SEWAGE DISPOSAL SYSTEM

HOWARD COUNTY HEALTH DEPARTMENT

UBDIVISION Twelve Hills LOT NUMBER 45 ADDRESS 13005 Red Maple Way

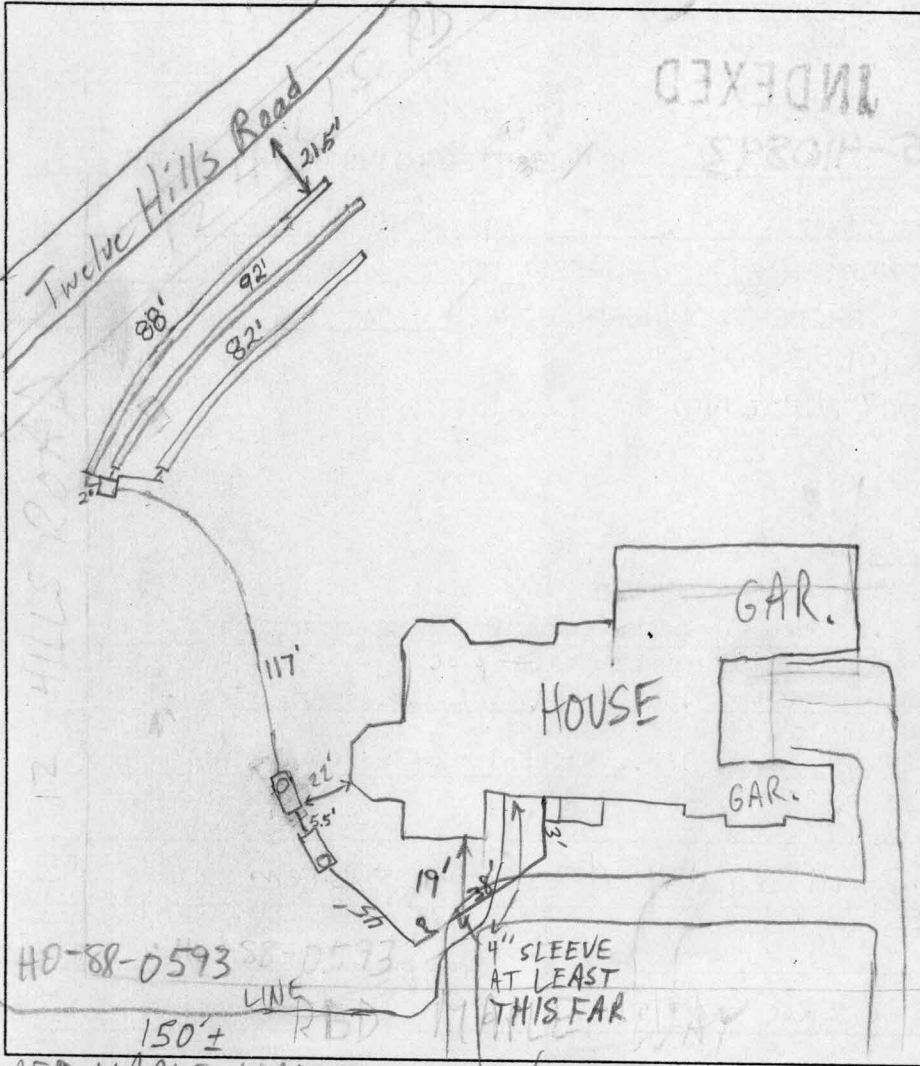
INSPECTION COMMENTS: 4/23/01 3:00 TANKS, D.B. SET; CONTINUE (MR) 4/25/01

Need house connection, alarm and pump test for final approval (MR) 4/29/01 NO WORK (MR) House connection OK

Bob Herrera (Supervisor) Says water line is jacketed all way, put sewer line by 10ft (water line is buried @ 4' below

sewer line, which needs 1 1/2 ft of fill to cover (only 6" in ground now). RP 9/11/01 12/20/01 No show for test (SO)

12/26/01 Pump & Alarm tests OK (E)
